**Category:** CDP

**Request ID:** CDP-2406-21

**Project Name:** Fahey South

To: Lisa McNabola  
Sonja Kruesel  
From: Brian Munson  
CC: Chris Ehlers  
Tony Heinrich  
David Fahey  
Grant Emmel  
Date: Friday, October 15, 2021  
Re: Fahey Property Comprehensive Development Plan Staff Comment

**SITE  
ANALYSIS &  
NEIGHBORHOOD  
PLAN OVERLAY**

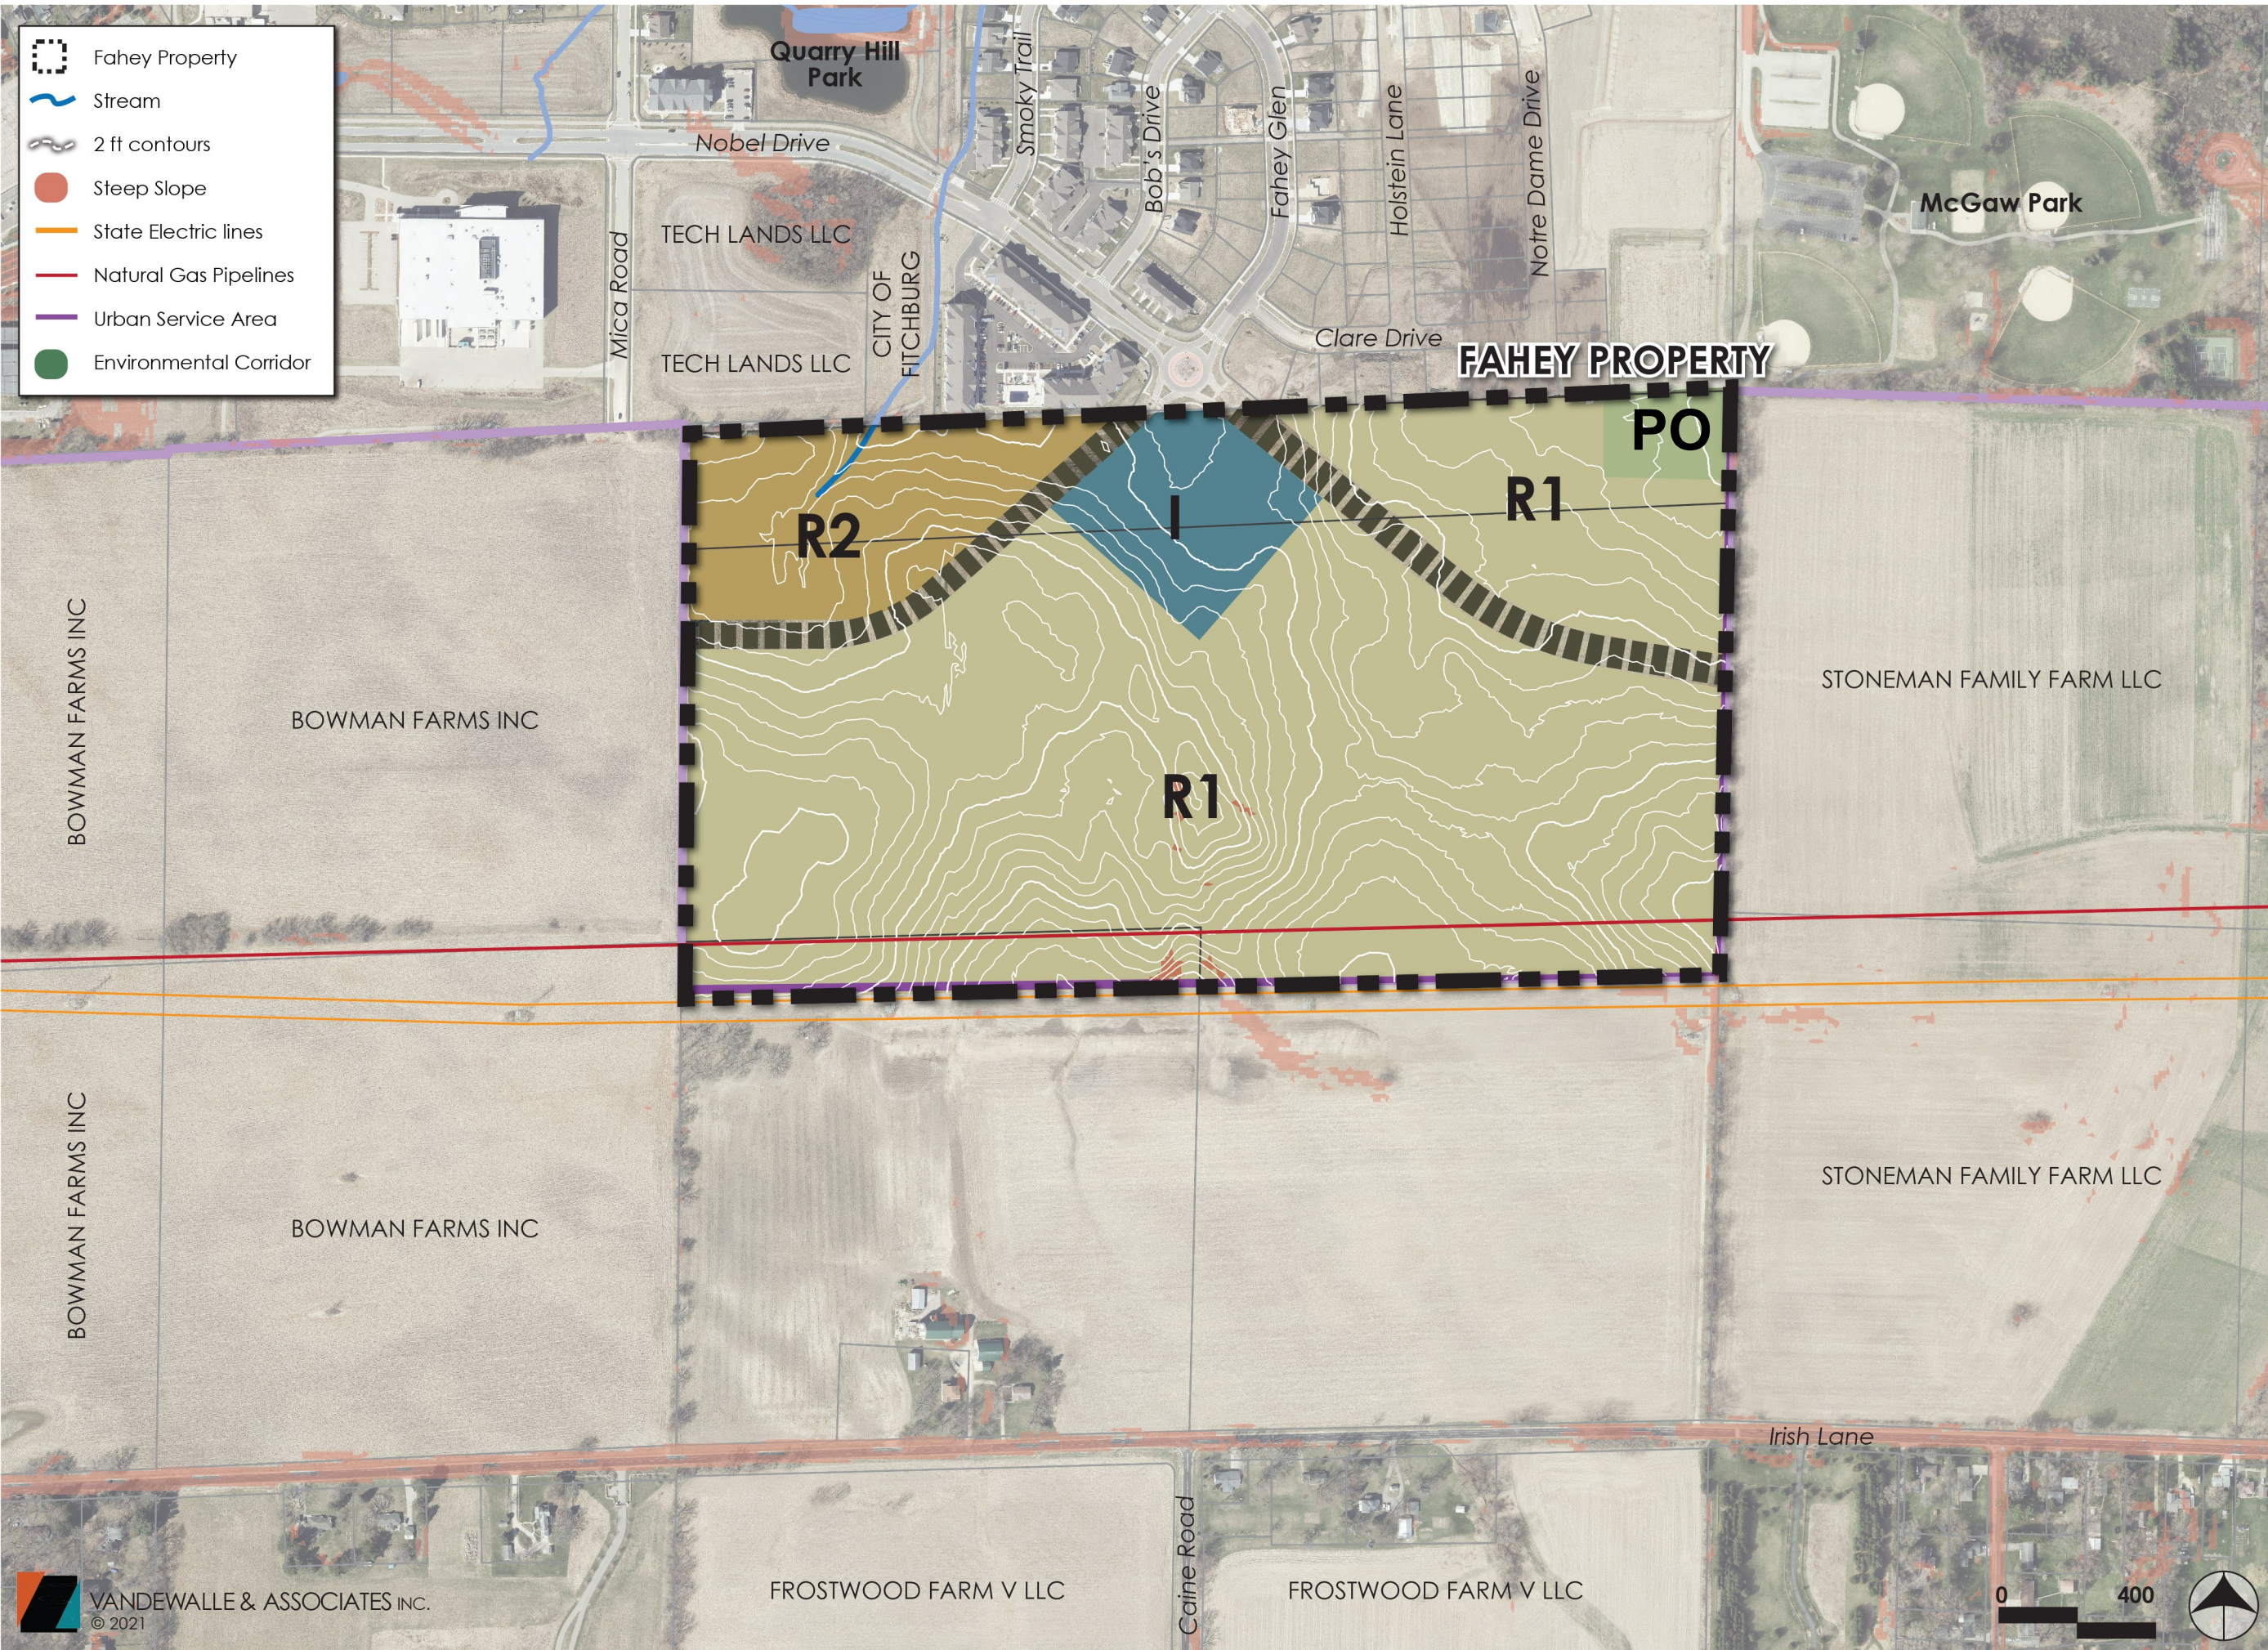
11. Site Analysis Exhibit – label P&O area

Added

## CONCEPT PLAN

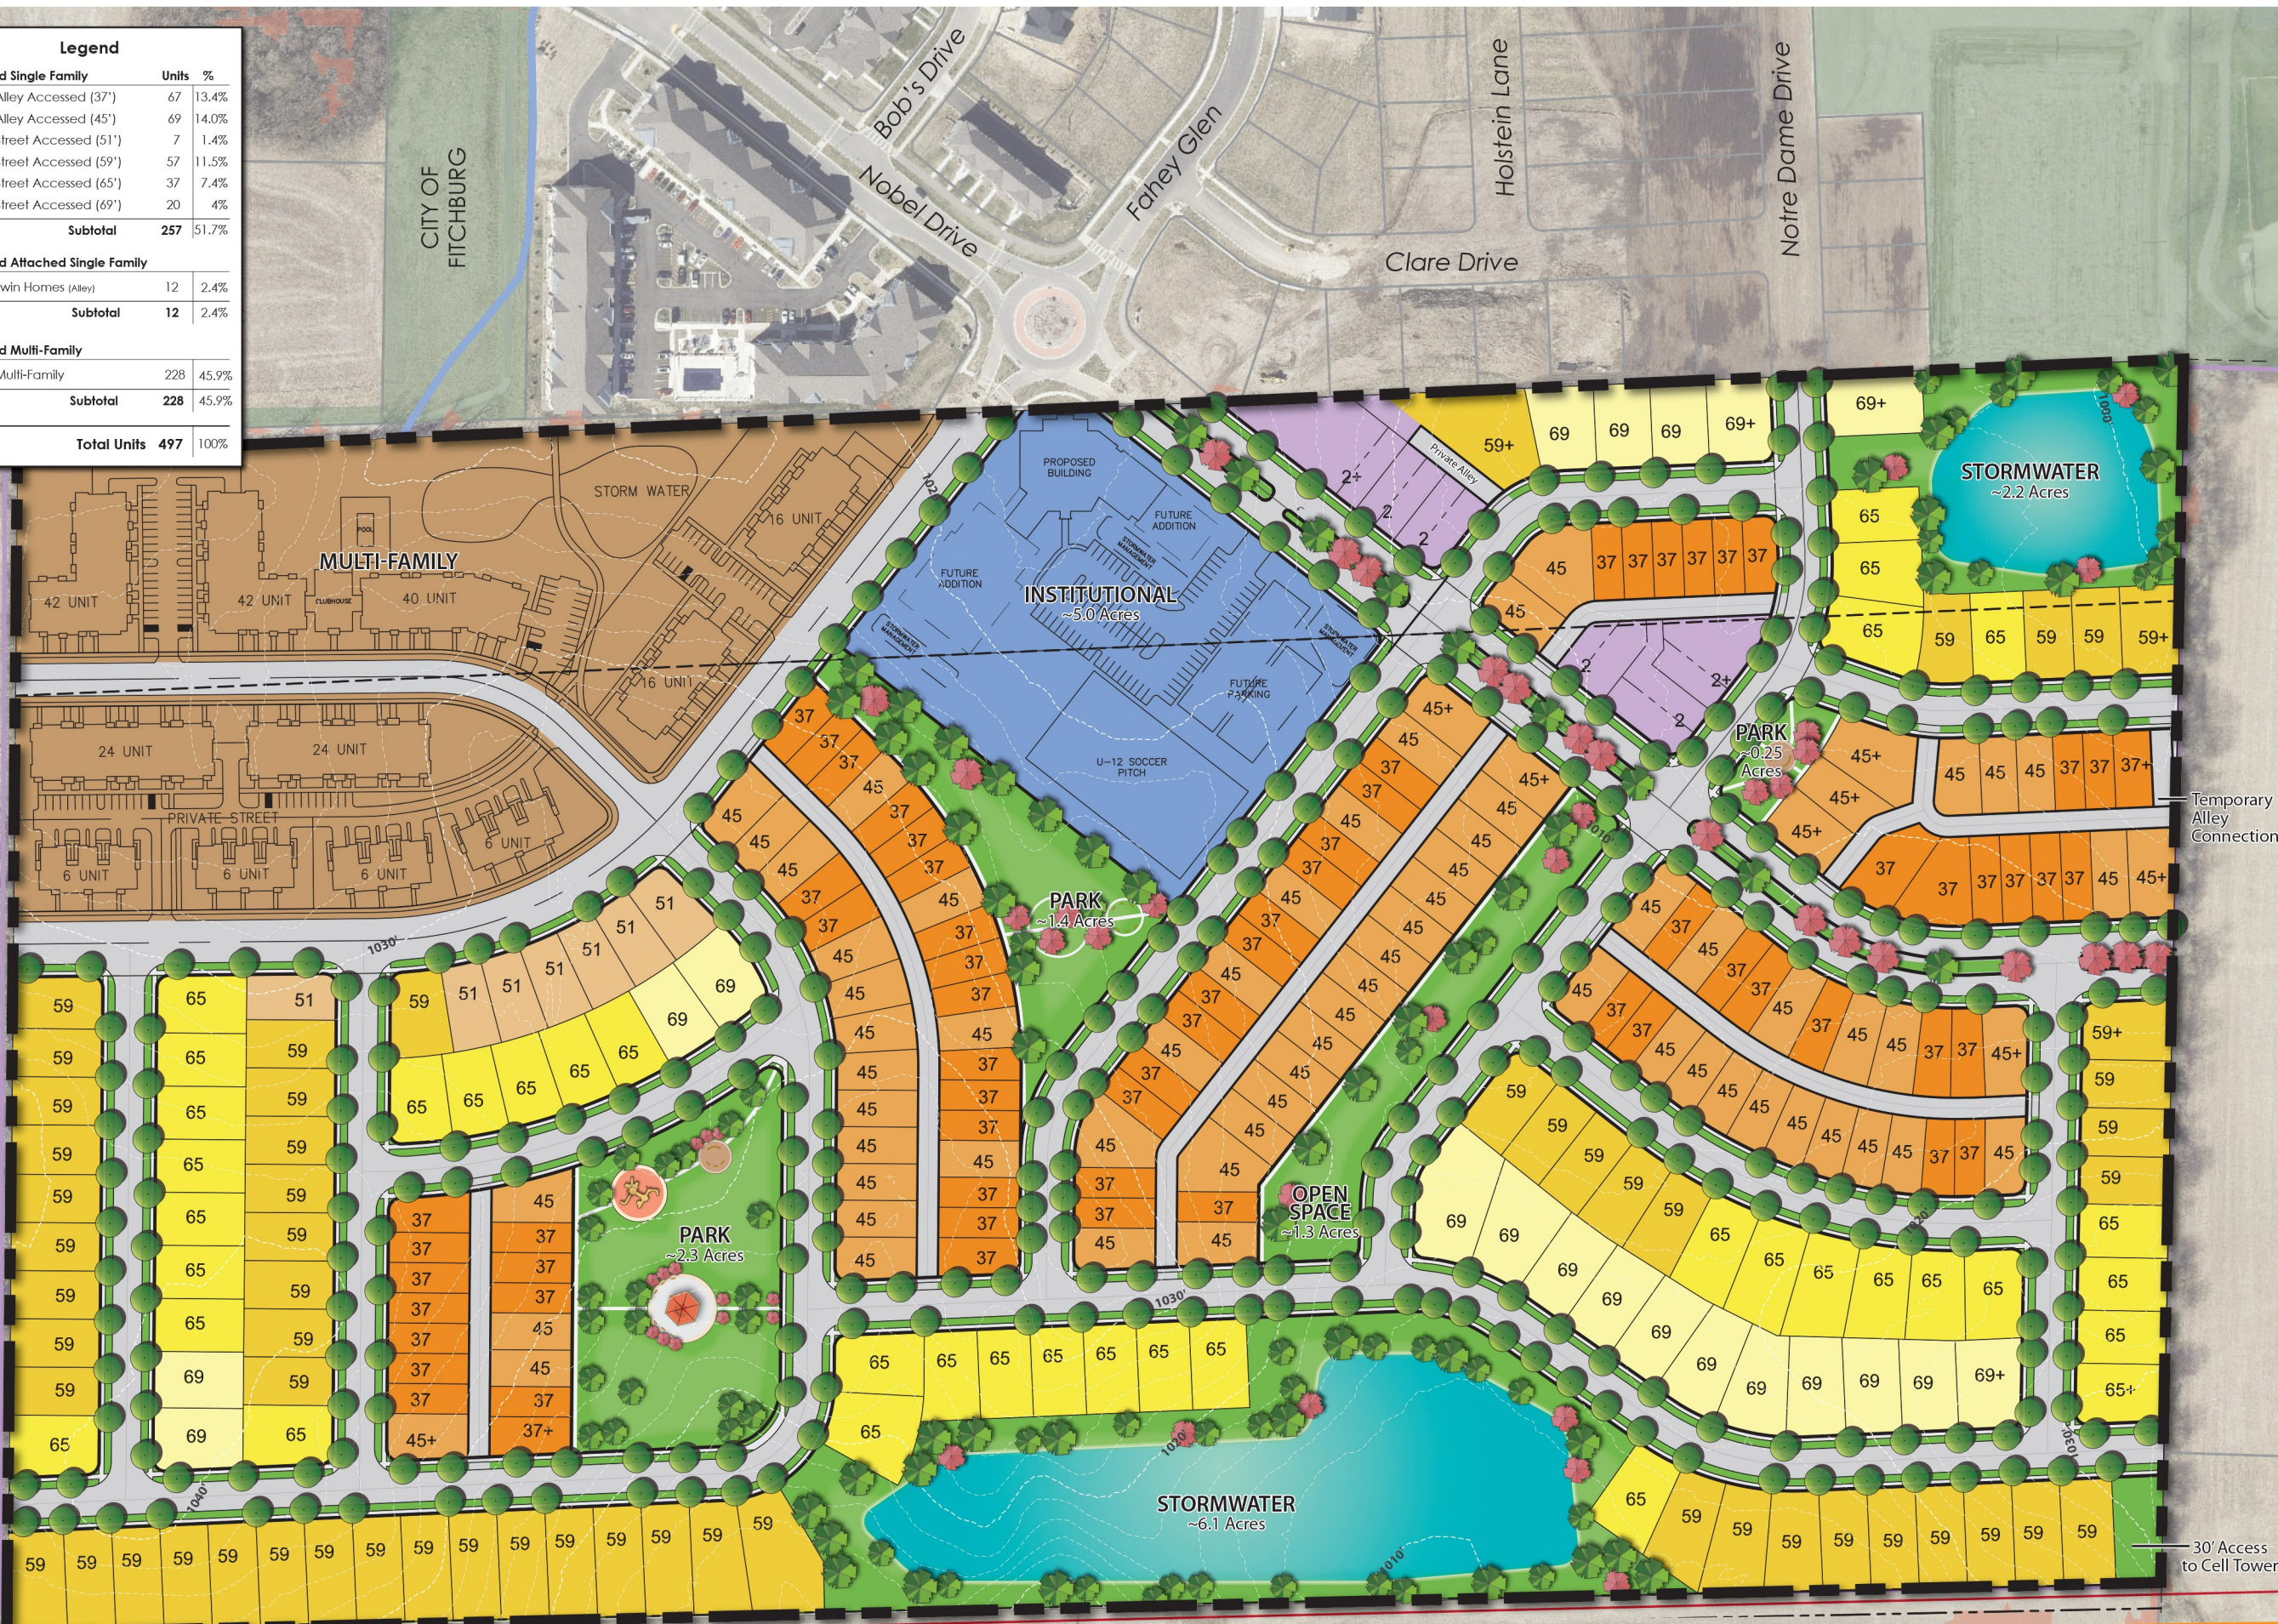
10. Concept plan – show lot lines for zero lot duplexes

Added

**ESTIMATED  
PHASING  
PLAN**

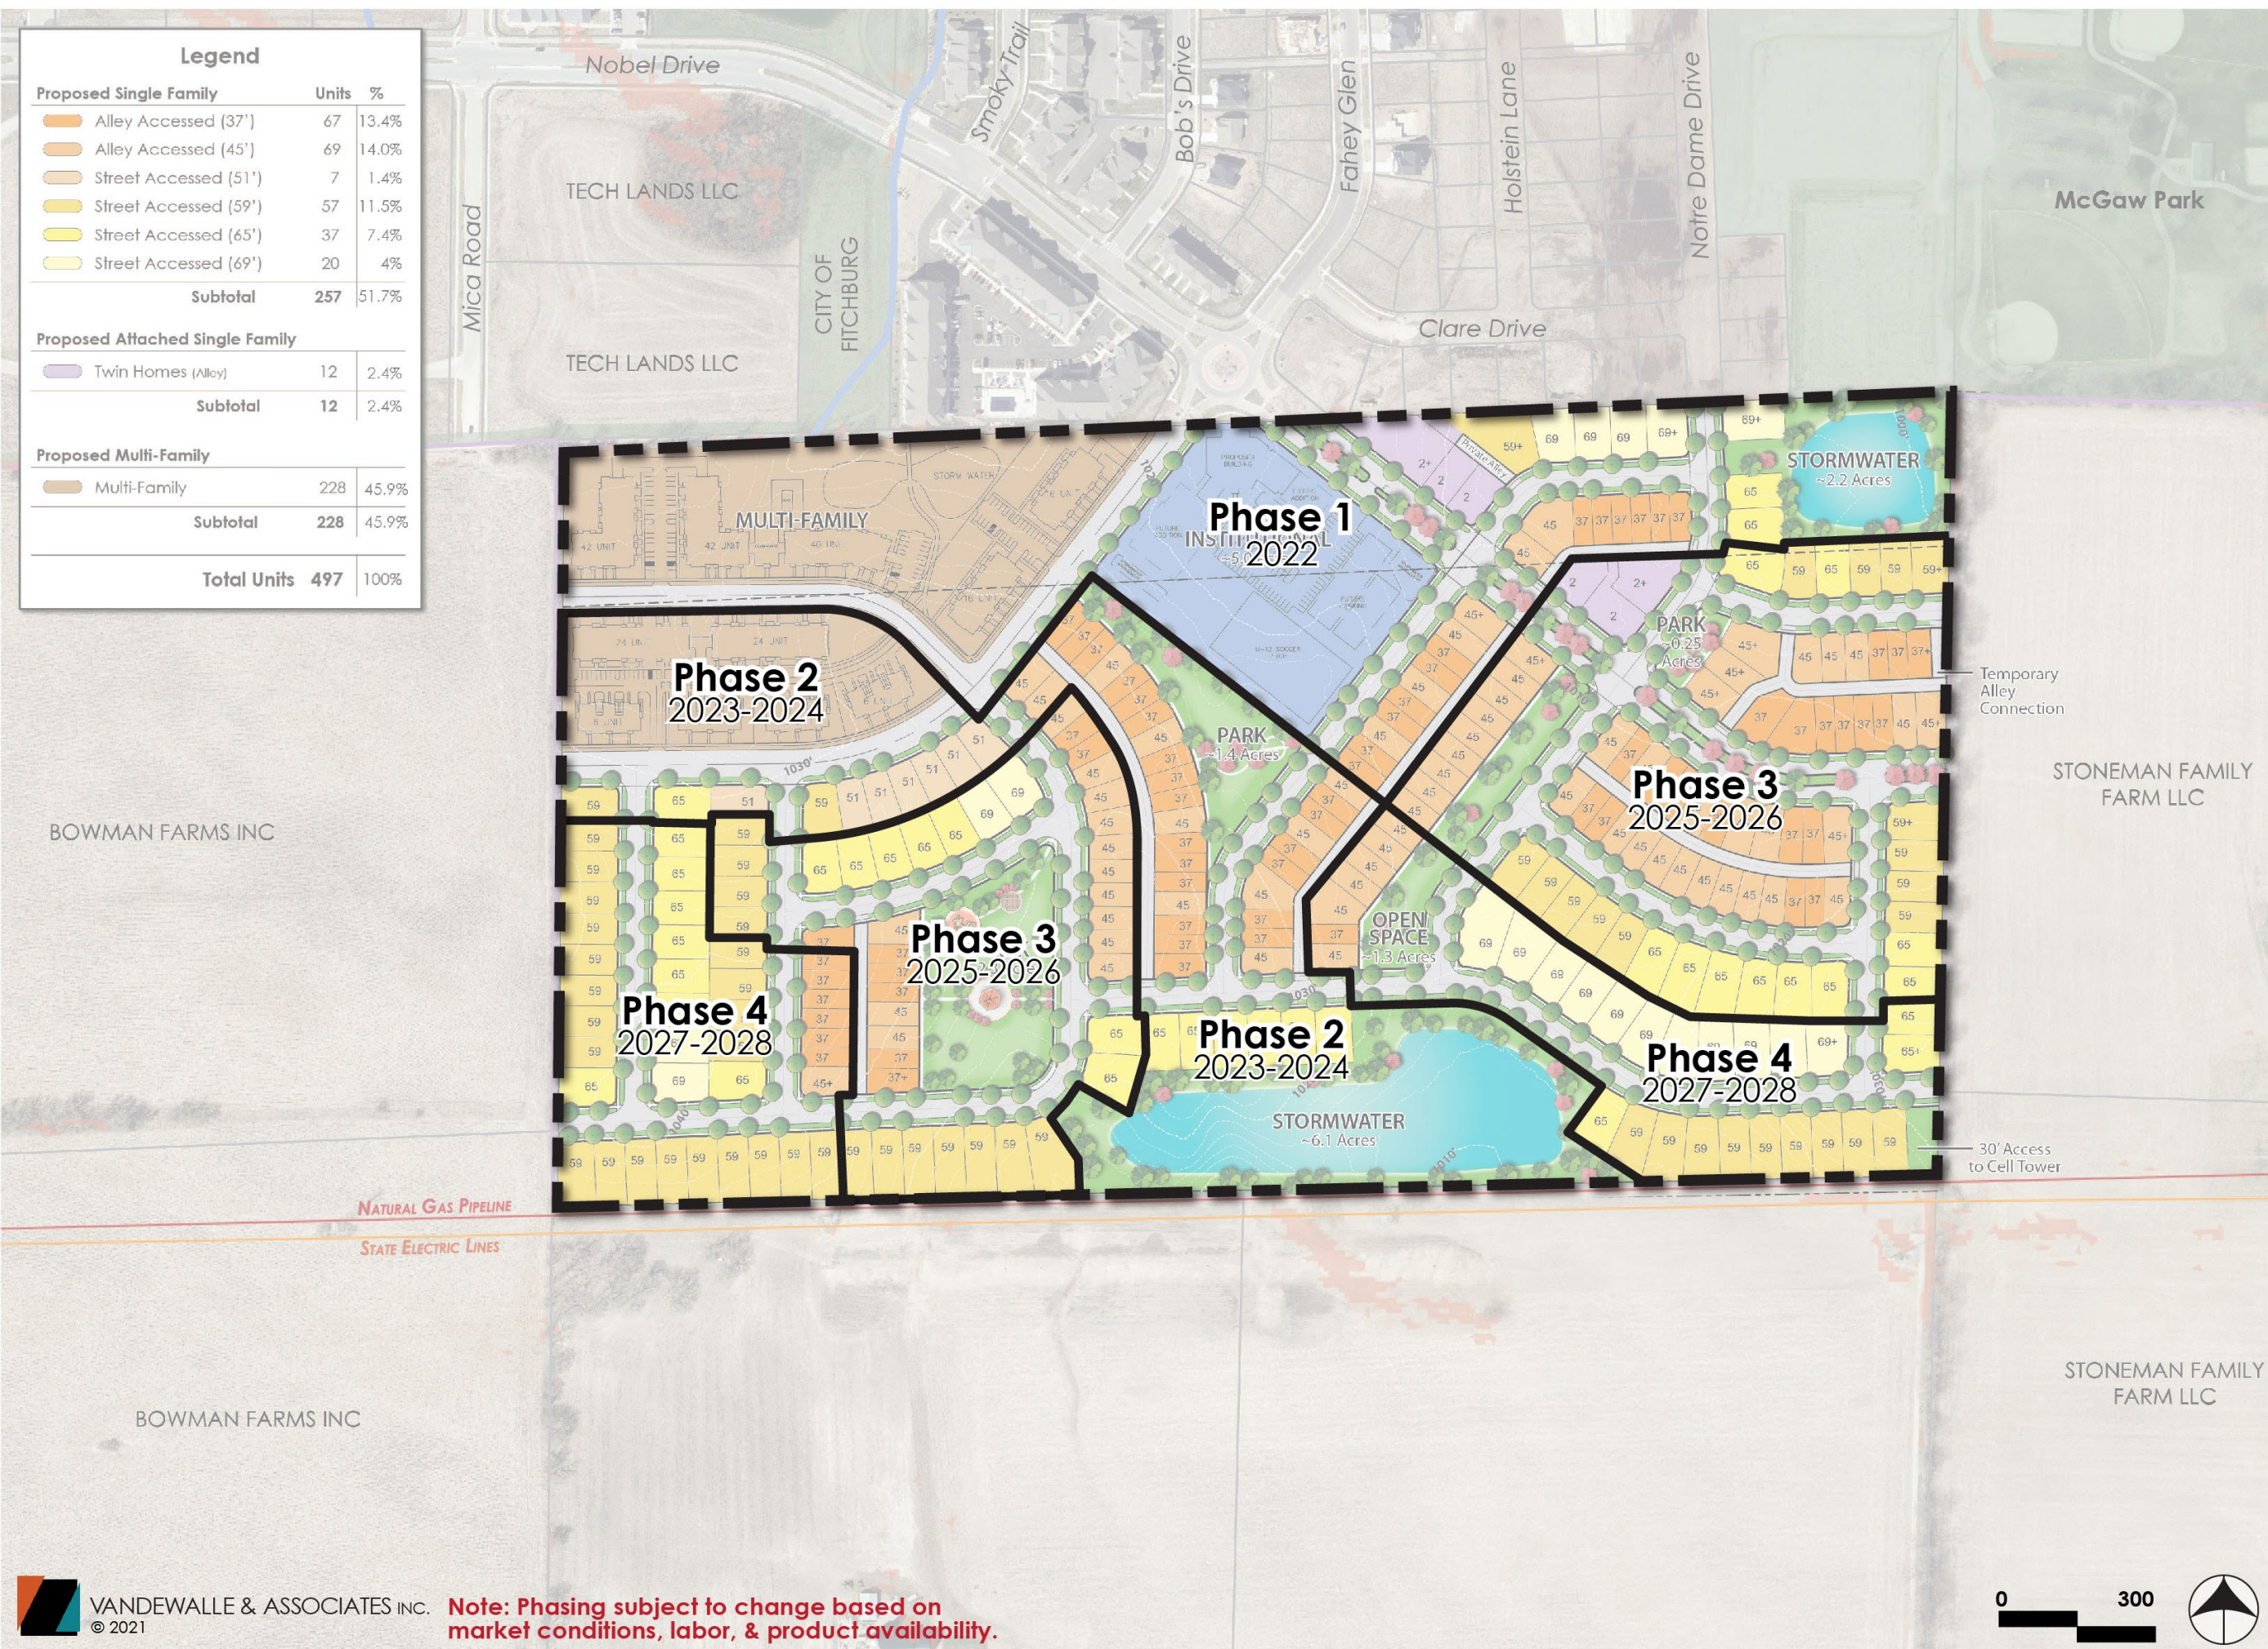
7. Phasing plan may not exceed 4 phases. Update accordingly.  
Incorporated into revised submittal document.

Incorporated into revised submittal document. The phasing for the project has been revised to contain 4 phases, per engineering comments.
